STAFF REPORT

APPLICATION RZ/FDP 2012-MA-022

APPLICANT: CG Peace Valley, LLC

PROPOSAL: The applicant seeks to rezone 1.89 acres from R-3 to PDH-4 to permit the development of seven single family detached dwelling units at an overall density of 3.71 du/ac.

CONCEPTUAL
STORMWATER
MANAGEMENT PLAN

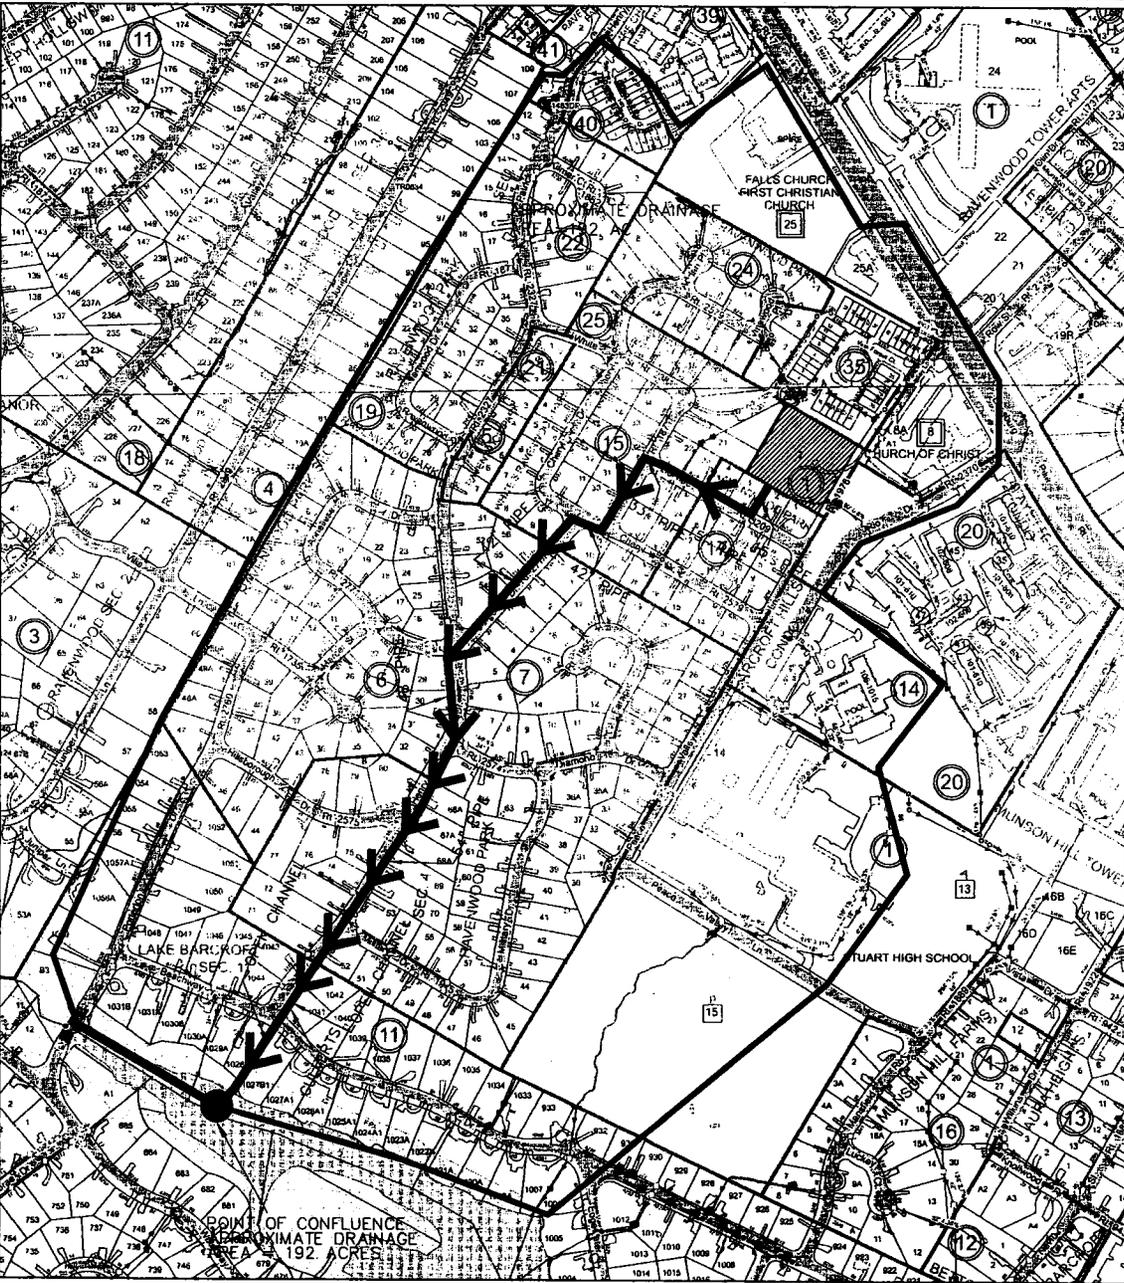
Stormwater Management: There are currently no stormwater controls on the site. According to the Stormwater Management narrative on Sheet 7A of the CDP/FDP, the applicant proposes to provide an underground infiltration trench designed to exceed quality and quantity requirements in the County Public Facility Manual (PFM). Design details for the proposed infiltration trench are included on Sheet 7A. Best Management Practices (BMP) would be provided by the infiltration trench and the proposed preservation area. Approximately 65% phosphorous removal is proposed to be achieved, which will exceed the 40% phosphorous removal requirements. The applicant has proffered to submit a formal geotechnical report referencing this facility to DPWES for review and approval by the Geotechnical Review Board (GRB). Any resulting recommendations would be implemented during final engineering. The report will be prepared per PFM Chapter 4 and Chapter 6-1300 guidelines and will include both a seepage analysis and a slope stability analysis of the area and slope north of the proposed infiltration facility. This additional analysis would also be provided to further demonstrate no adverse impact to the adjoining properties with respect to their stability and usage. If warranted by the GRB and final engineering, minor modifications to the size, location, and configuration of the SWM facility may be made in connection with subdivision plan approval; provided, however, that such changes will not diminish the effectiveness of any required screening, landscaping, and tree preservation shown on the development plan. If the modifications are not approved by DPWES, a Proffered Condition Amendment may be required.

Water Quality Control: The applicant indicated on Sheet 7 of the CDP/FDP that 65% phosphorus removal would be met through combination of infiltration trench and conservation easement. The location of infiltration trench has been depicted in the plan and preliminary phosphorous removal computation has been provided. The feasibility of the infiltration trench must be demonstrated with final engineering during subdivision review. If the trench is not feasible, a Proffered Condition Amendment may be required.

Applicant stated on sheet 7 that phosphorus removal requirements will be met through combination of infiltration trench and conservation easement. The location of infiltration trench has been depicted in the plan and preliminary phosphorous removal computation has been provided. The feasibility of the infiltration trench shall be demonstrated prior to rezoning approval.

In order to address these concerns identified in the field, the applicant indicated that the design of the underground infiltration trench would exceed quality and quantity requirements in the Public Facility Manual (PFM). Design details for the proposed infiltration trench are included on Sheet 7A of the CDP/FDP. The applicant has also proffered to submit a formal geotechnical report referencing this facility to DPWES for review and approval by the Geotechnical Review Board (GRB). Any resulting recommendations would be implemented during final engineering. The report will be prepared per PFM Chapter 4 and Chapter 6-1300 guidelines and will include both a seepage analysis and a slope stability analysis of the area and slope north of the proposed infiltration facility. This additional analysis would also be provided to further demonstrate no adverse impact to the adjoining properties with respect to their stability and usage. If warranted by the GRB and final engineering, minor modifications to the size, location, and configuration of the SWM facility may be made to the SWM facility in connection with subdivision plan approval; provided, however, that such changes shall not serve to diminish the effectiveness of any required screening, landscaping, and tree preservation shown on the development plan. If the modifications are not approved by DPWES, a Proffered Condition Amendment may be required. Final determination would be made with final engineering during subdivision review.

Graphic 1: Proposed Site Layout

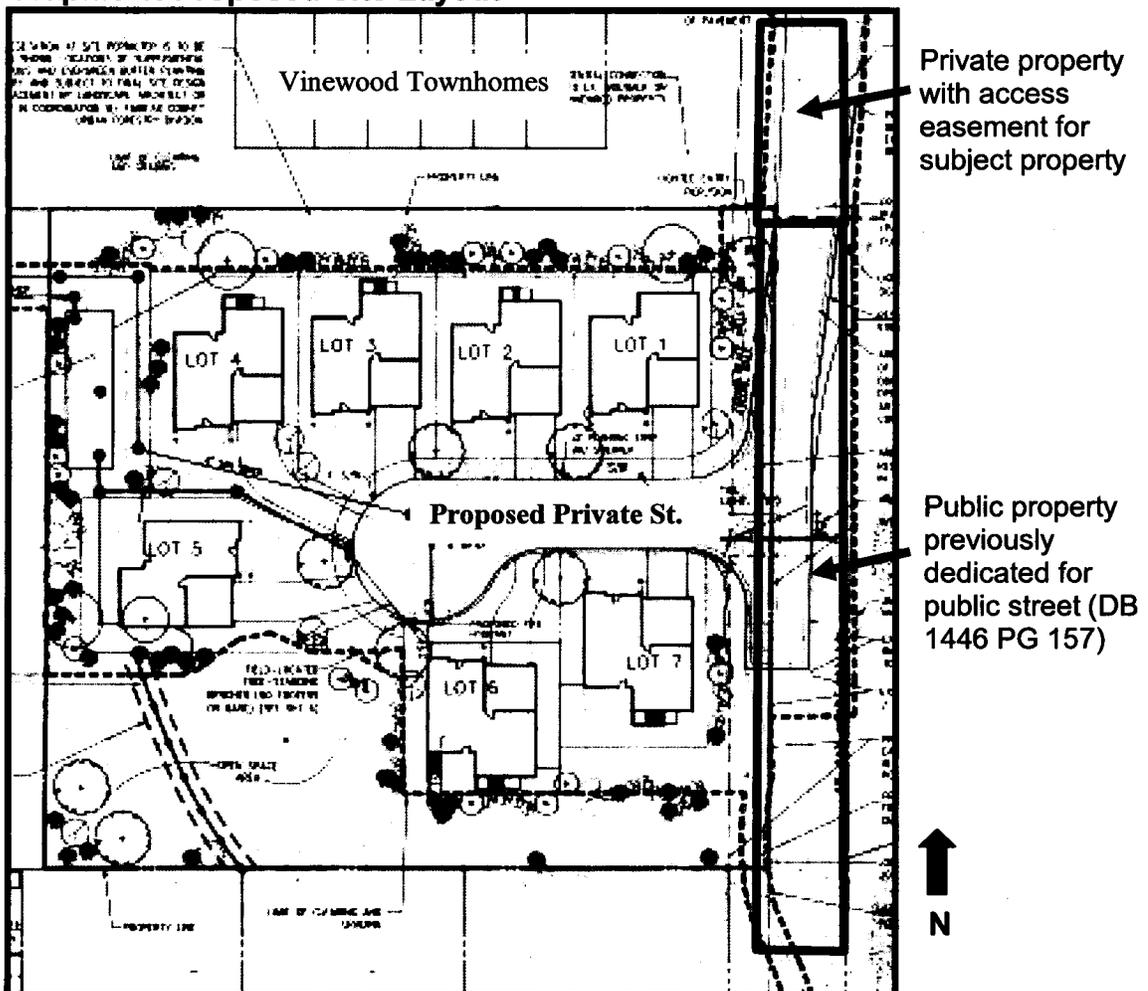
The current development plan depicts preservation of the 58 inch caliper Red Oak and several other trees in this area; however, the development plan depicts a permanent diversion dike traversing the open space/tree preservation area. Staff is concerned that the diversion dike will disturb the root system of the Red Oak, as well as other trees located in this area. The applicant indicated that the diversion dike is critical to help reduce uncontrolled surface runoff and channelize it towards an existing storm sewer inlet. The CDP/FDP has been revised to shift the location of the diversion dike further away from the critical root system of the Red Oak. In addition, the applicant proffered to install the diversion dike on grade without any disturbance to existing grades by hand under the direct supervision of a certified arborist in order to minimize disturbance to the critical root zones of trees being preserved, subject to review and approval by Urban Forest Management Division (UFMD) of DPWES. Further analysis is provided below in the Tree Preservation criteria.

The plan indicates that a diversion dike is proposed southwestern part of site to divert part of the site into an existing storm sewer inlet. The post development flow to this inlet must not exceed the predevelopment flow.

The applicant revised the CDP/FDP to remove the jog in the street, include a channelization device at the intersection of Peace Valley Lane and Leesburg Pike that would be reviewed and approved by VDOT, and provide a continuous asphalt and cement trail from Colmac Drive to Leesburg Pike. The applicant also revised the proffers to reflect these improvements and to ensure that the established homeowners association will maintain the new private street. The applicant proffered to contribute an initial escrow of \$12,500 to fund a reserve account for the maintenance of the private street. Staff continues to negotiate with the applicant for additional contributions to the maintenance fund. No other issues remain.

- XIV. Diversion Dike. The diversion dike located in the southwestern corner of the site shown on sheet 4 of the CDP/FDP shall be installed on grade without any disturbance to existing grades and under laid with root aeration matting, by hand without the use of any wheeled or tracked equipment, under the direct supervision of the Project Arborist in order to minimize disturbance to the critical root zones of trees being preserved, subject to review and approval by UFMD.

Graphic 2: Proposed Architectural Elevations

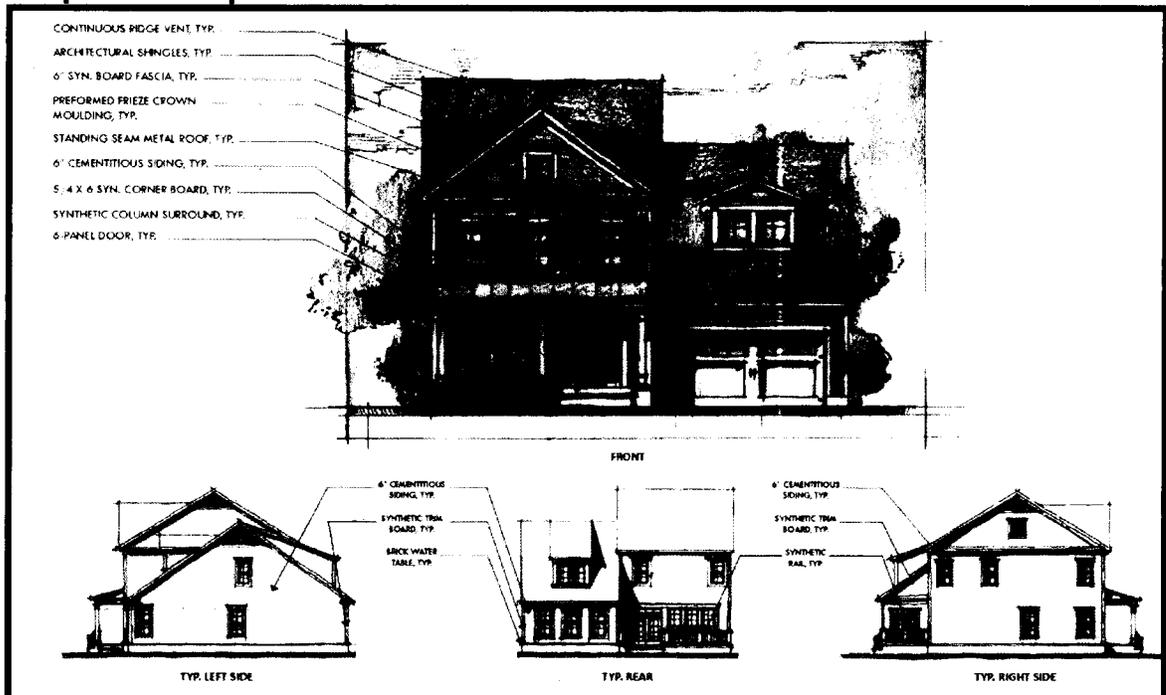
Development should fit into the fabric of the community as evidenced in the architectural elevations and materials. Existing two story townhomes and one to two story single-family detached dwelling units are located to the north and south of the subject property. Sheet 2 of the CDP/FDP shows the maximum building height for the proposed single-family dwelling units is 35 feet or two stories.

Sheets 9 through 10 of the CDP/FDP show elevations of the proposed single-family units, and the applicant has proffered to use the same quality, general appearance, style and proportion of materials depicted on the illustrative perspective and elevations on the CDP/FDP. Sheet 6A of the CDP/FDP shows a site section, which demonstrates a relationship in terms of height and setbacks for the proposed dwelling units to the existing adjacent dwelling units located to the north and south. The proposed units would be approximately 80 feet from the existing adjacent dwelling units to the north and south, and would not tower over the existing dwelling units. Staff finds that the proposal would fit into the fabric of the community.
